Official Transcript of Proceedings
NUCLEAR REGULATORY COMMISSION

Title: Advisory Committee on Reactor Safeguards
 US-APWR Subcommittee

Date: Wednesday, November 20, 2013

US-APWR SUBCOMMITTEE

Severe Wind v.s. Extreme Wind

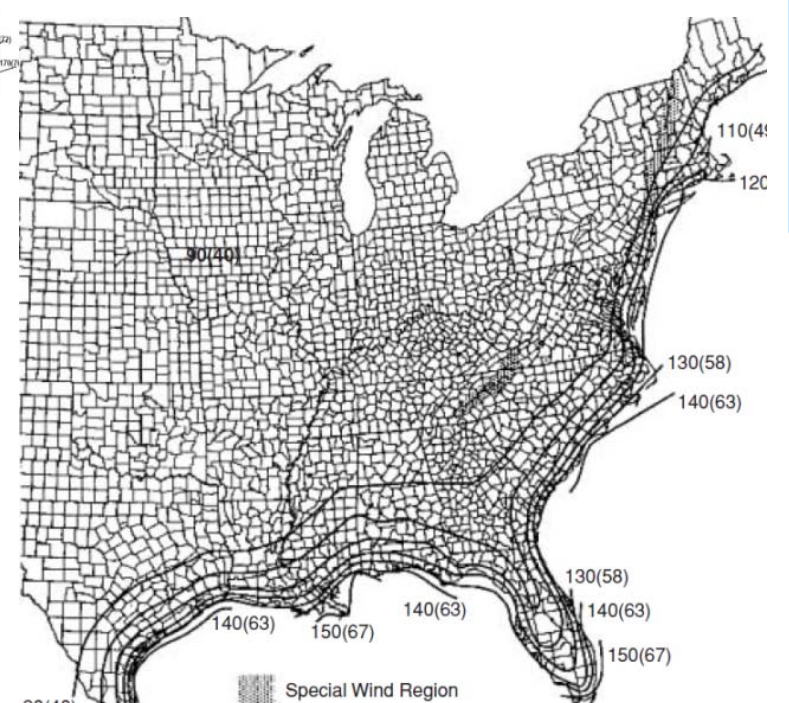
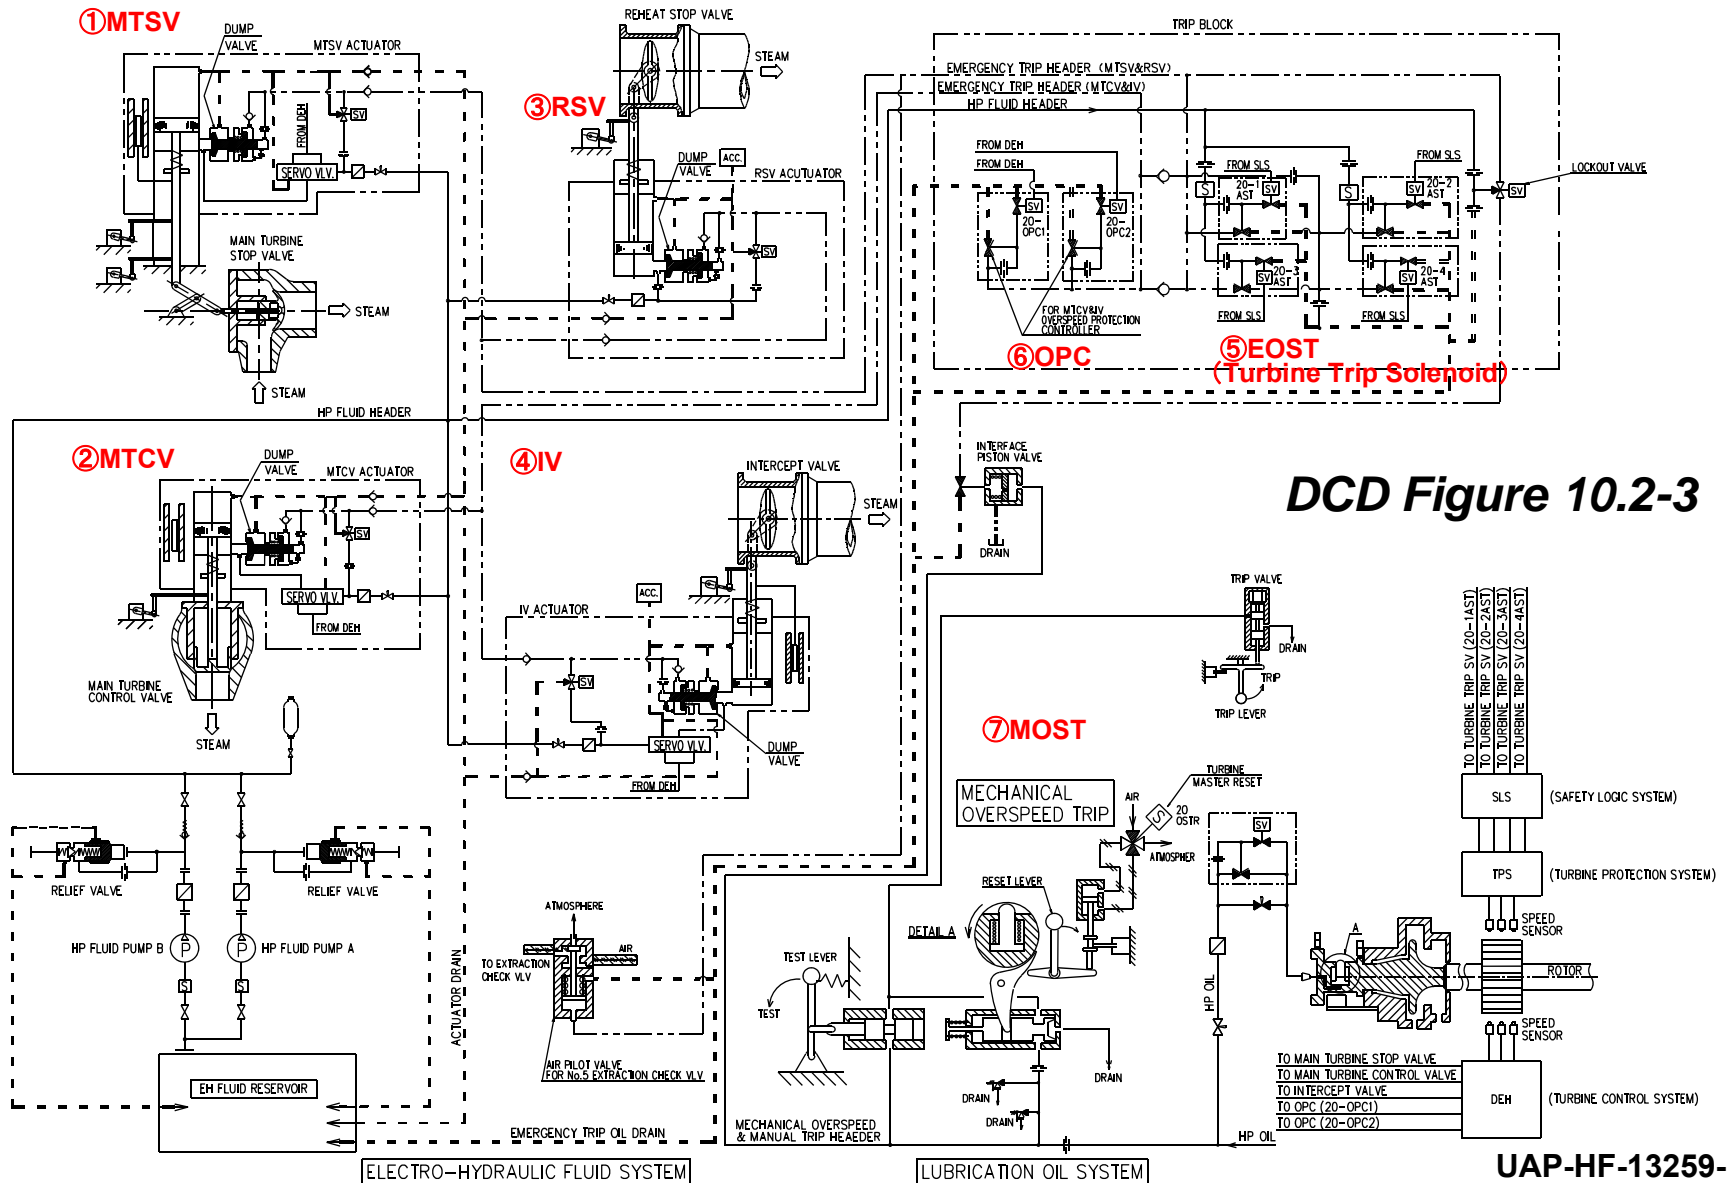
20 MEMBER RICCARDELLA: Well, no, my question
21 is specifically about Section 3.3 of the 07028 Report.

4 MR. OGASAWARA: Before going to the
5 question, can I answer to the question in Section 3.3 the
6 wind speed 155 and also 160 questions?

8 MR. OGASAWARA: Could you show the
9 presentation, Page 30? One hundred fifty-five is the
10 probability of ten to the minus two per year. This is
11 a severe wind and 160 miles per hour is a ten to the minus
12 six, that is extreme wind and in our DCD we call it as
13 hurricane.

3 If in the site conditions the winds are
4 higher than 155 or the number is higher than 160, the COL
5 applicant have to show, has the responsibility for the
6 design.

(MUAP07029 Table 5.1-1)

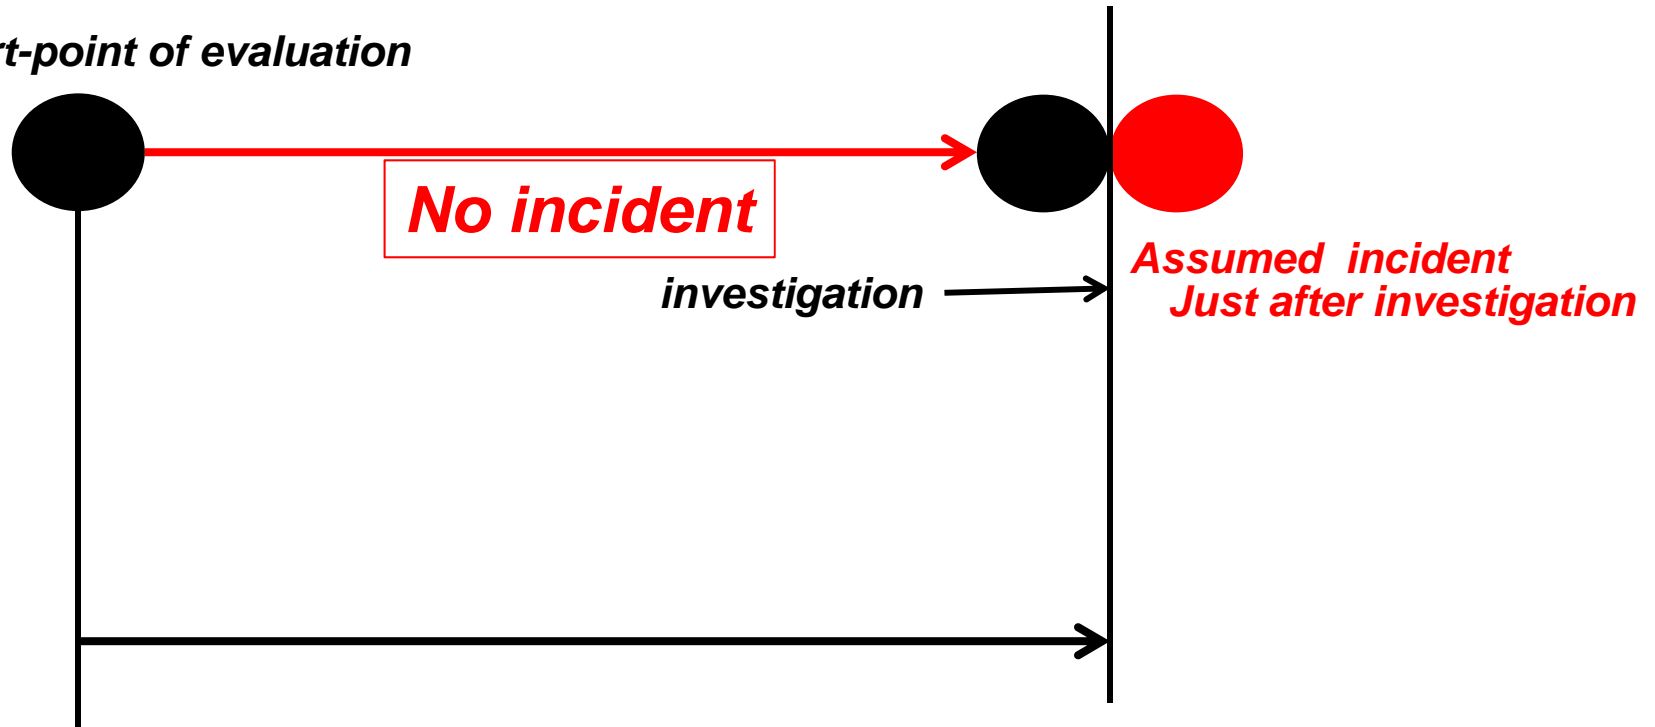
17 And I don't know, in the interest of time,
18 I have a lot of questions about how you derived your
19 failure frequencies for the turbine stop valves and
20 turbine control valves, because in many cases you didn't
21 have any operating experience.

4 That's just simply missing. It would add
5 to the frequency that's calculated from simply failures
6 of the end use devices which are the stop valves and
7 control valves themselves.

8 And you can't argue that it's included in
9 those stop valves and control valves because in my
10 experience the designs of the electronic systems and the
11 hydraulic systems differ from plant to plant.

12 They may be standardized in Japanese
13 plants, but they also have common cause failures and in
14 a sense that failures of, I think, I'd have to look up
15 equations, I think it would require failures of two
16 solenoid valves, but if those two solenoid valves fault,
17 none of the turbine stop valves and control valves would
18 close.

17 Now your experience base may never show a
18 failure of the turbine to trip because failure of only
19 one of those solenoid valves would not cause a failure
20 of the turbine to trip. You would need failure of at
21 least two.

2 You never had two of them fail, at least in
3 my understanding looking at your data. Ten to the minus
4 five per year is a really, really small event. You would
5 not have expected to see any of these events in the entire
6 operating history of all the Japanese nuclear power
7 plants.

5 CHAIRMAN STETKAR: Anyway, I'll just leave
6 it at the table, we've spent a reasonable amount of time.
7 If you can show me where, you know, where those things
8 are included or where, either in the model, and I don't
9 think they're included in the model, or in the data, I'd
10 be happy.

4 MR. MINAMI: But when I investigate our
5 experience in Japanese PWR plants and we investigated
6 every failure of the turbine control system, which
7 include the valve and the actuator, valve or sensing
8 around control systems.

13 So my intention is that I didn't explicitly
14 show the incident of the, for example, for the pickup or
15 for the micro-CPU or for the cable or something like that,
16 not divided into the detail, but I included all the
17 component included in the turbine control and protection
18 system.
